Addendum No. 2 Main Pump Building HVAC Upgrades Capital Project No. 2002

This Addendum No. 2, dated January 13, 2020, to the Invitation to Bid: Main Pump Building HVAC Upgrades, Capital Project No. 2002, bid opening January 16, 2020 at 1:00 pm, supersedes all contrary and conflicting information in the above-mentioned instructions, specifications, and contract documents which are hereby supplemented or revised in certain particulars as follows:

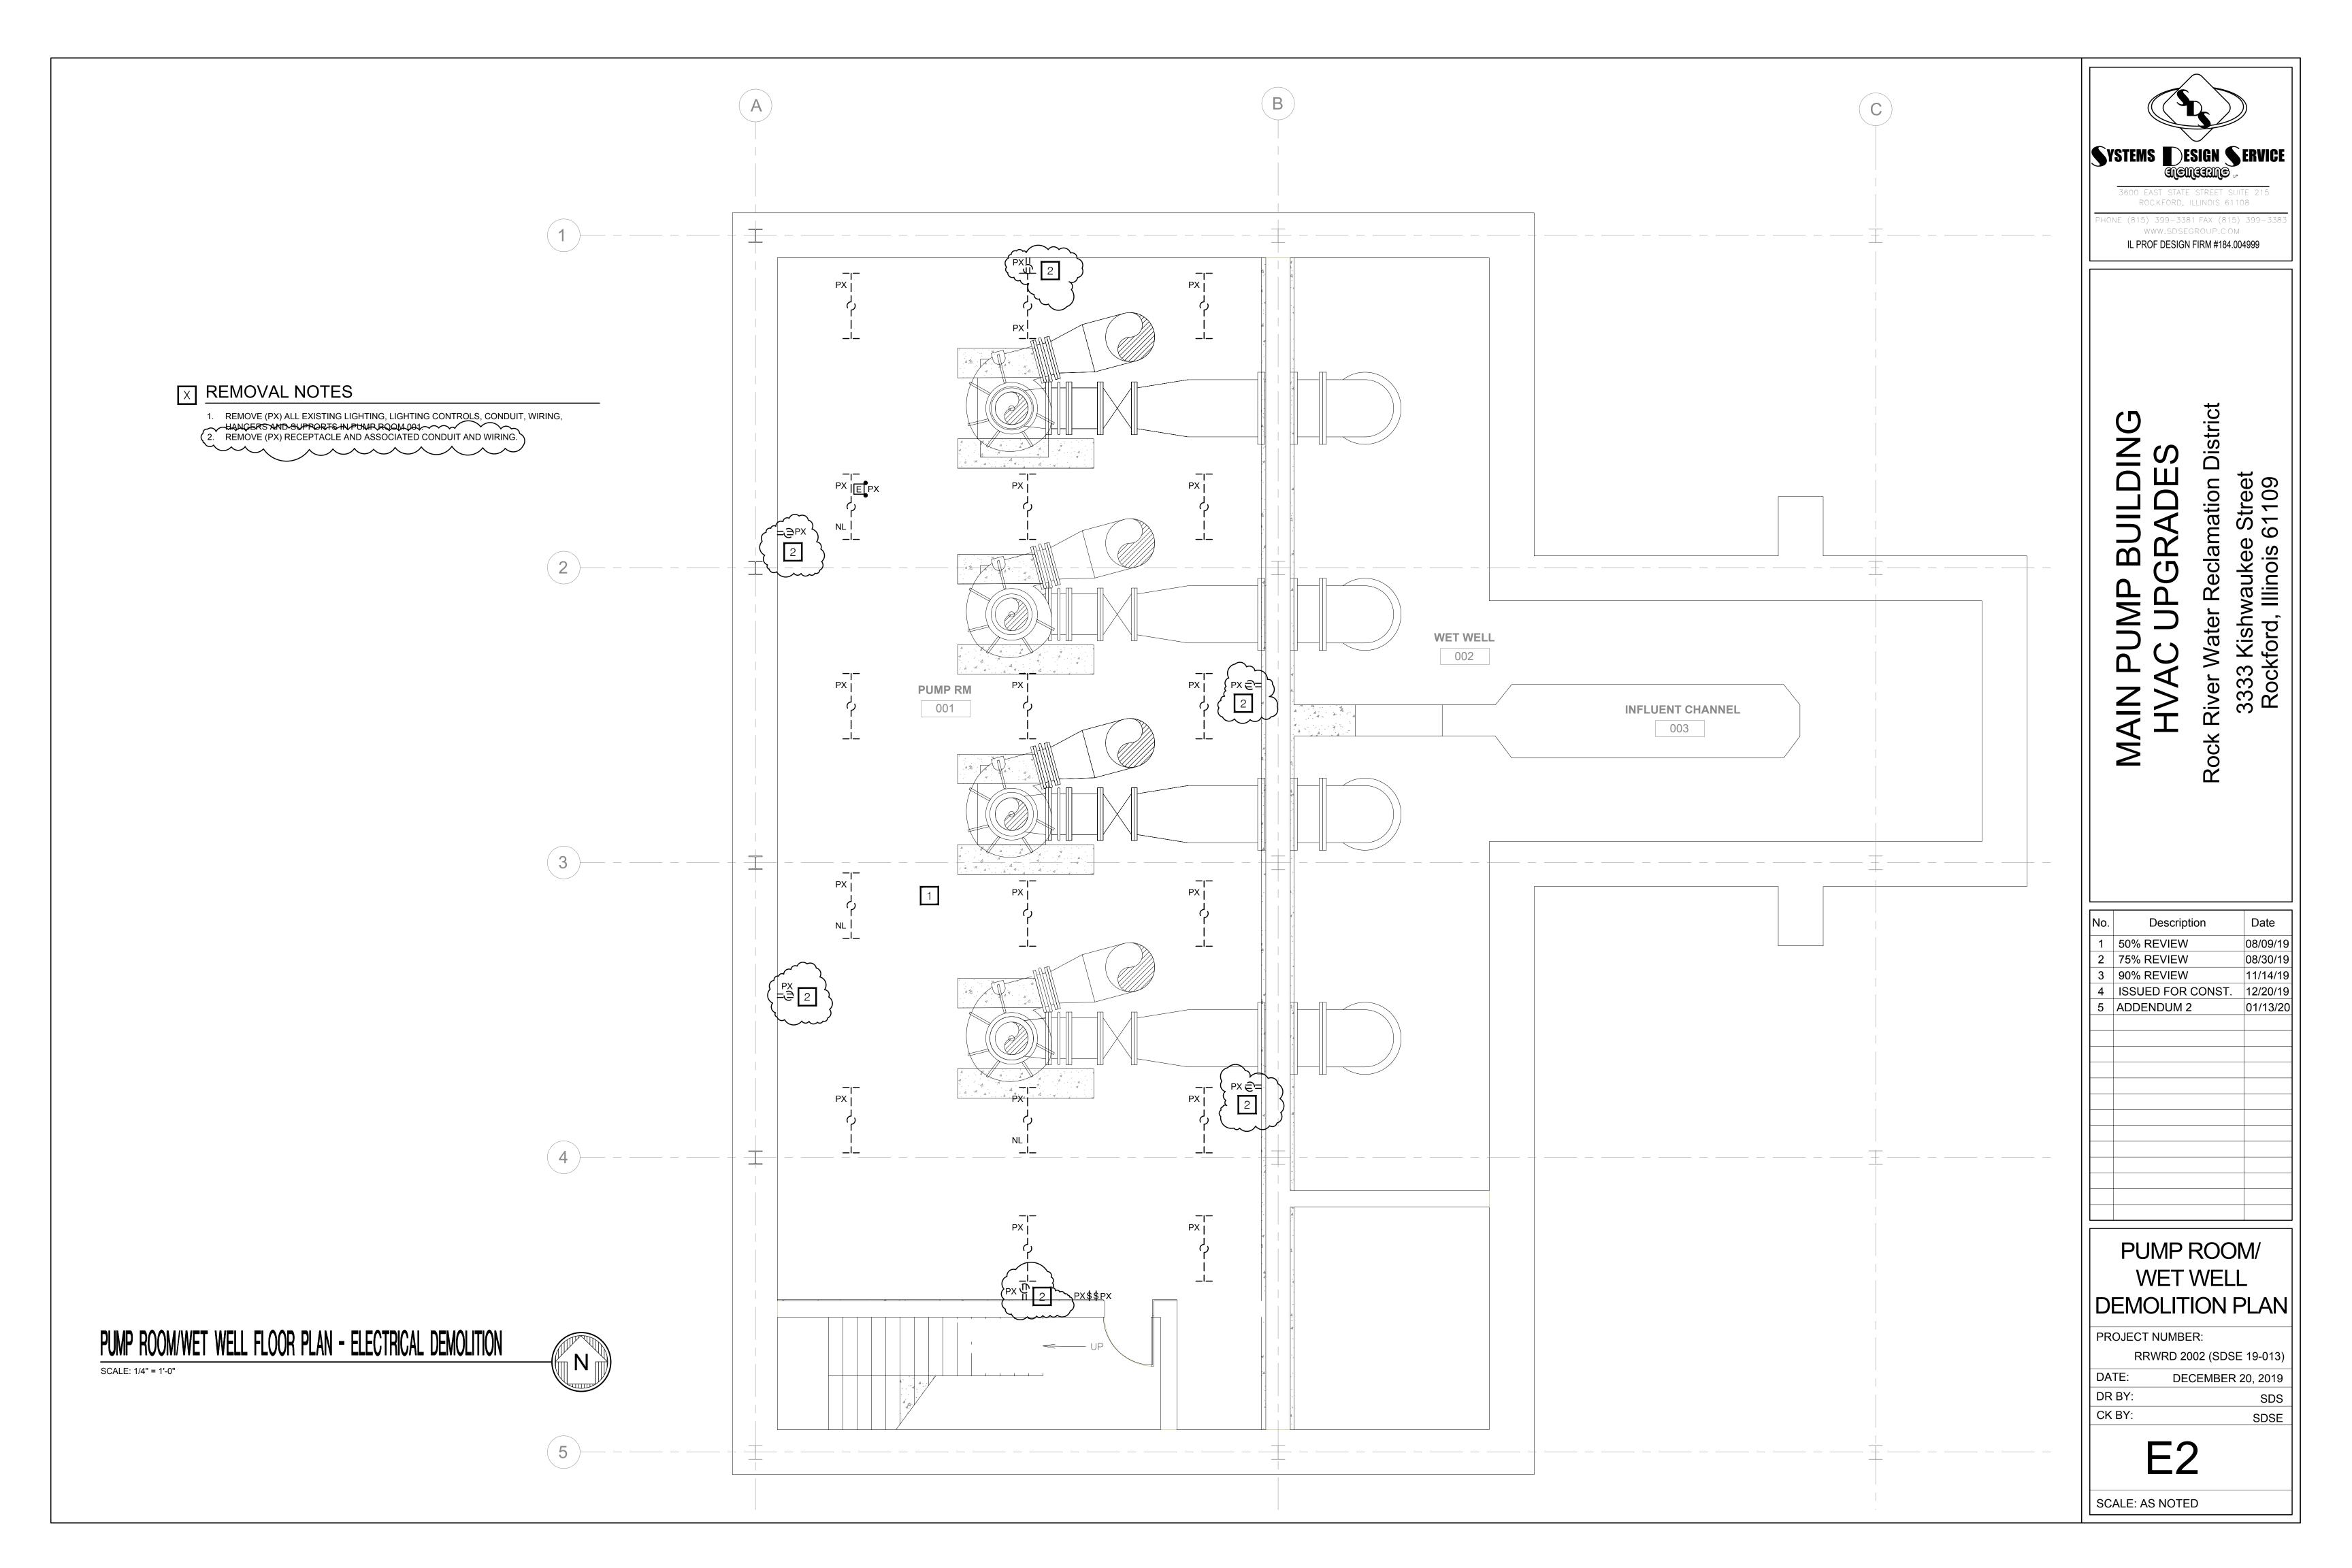
AD2-10 Sheet E1

Replace this drawing with the attached revised E1. The revisions include addition of two symbols to the Fire Alarm System Symbols and update of the LP-14A Panel Schedule.

MOTOR ROOM/LOWER SCREEN ROOMS FLOOR PLAN - ELECTRICAL DEMOLITION

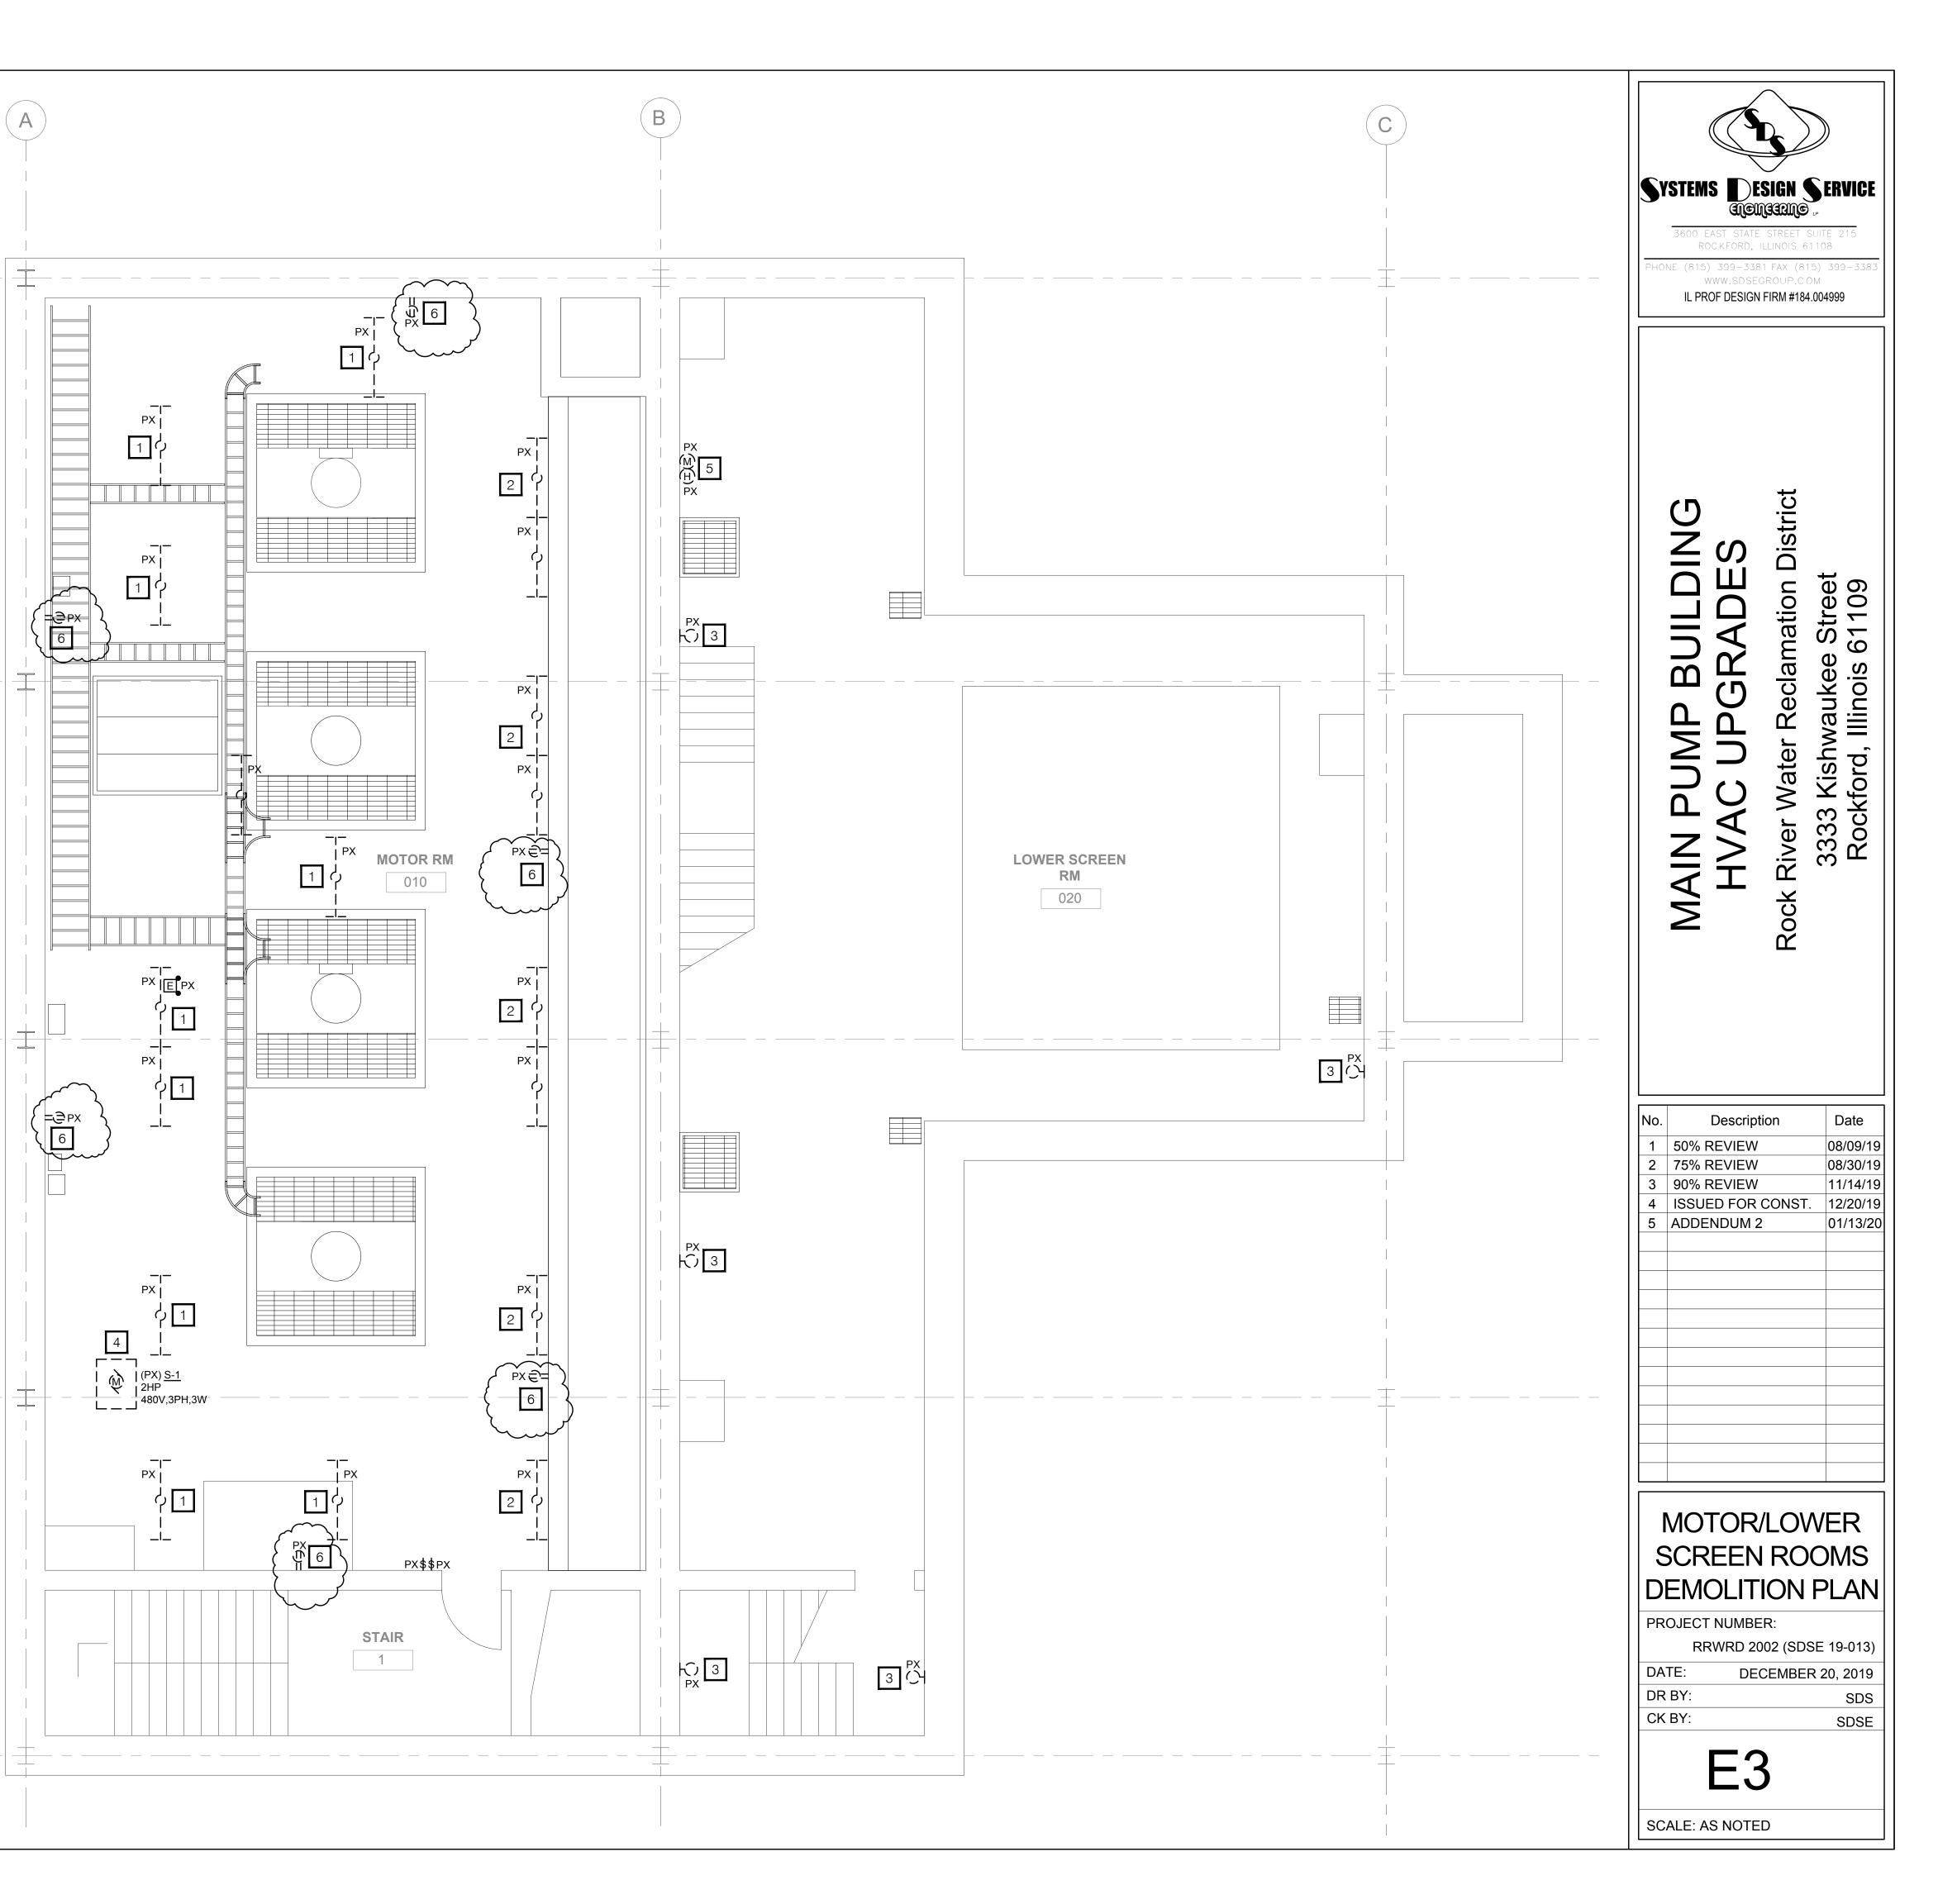
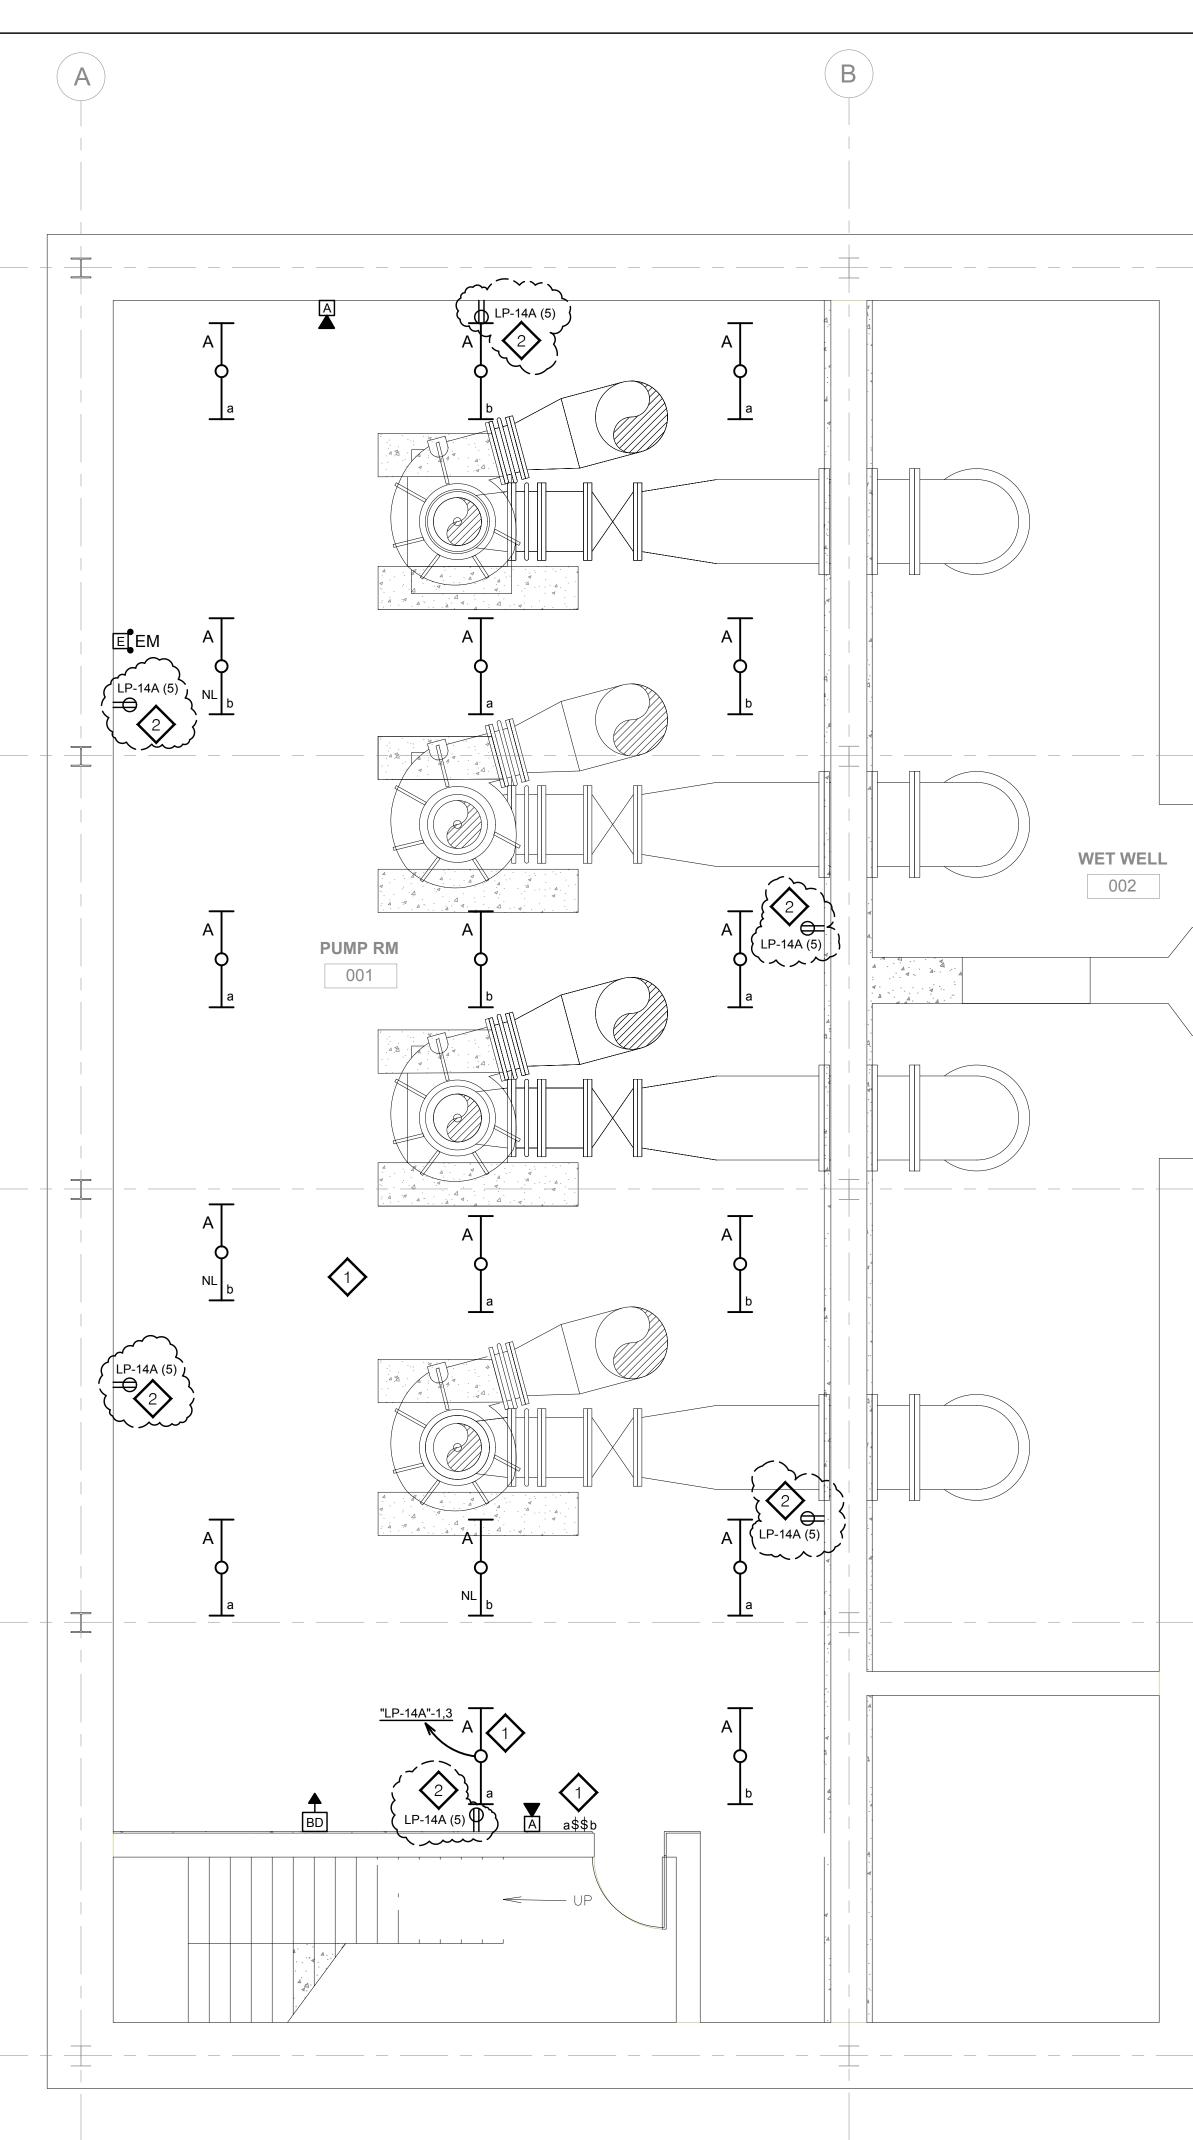
AD2-12 Sheet E3

Replace this drawing with the attached revised E3. The revisions include demolition of six receptacles, conduit, and wiring in the Motor Room.
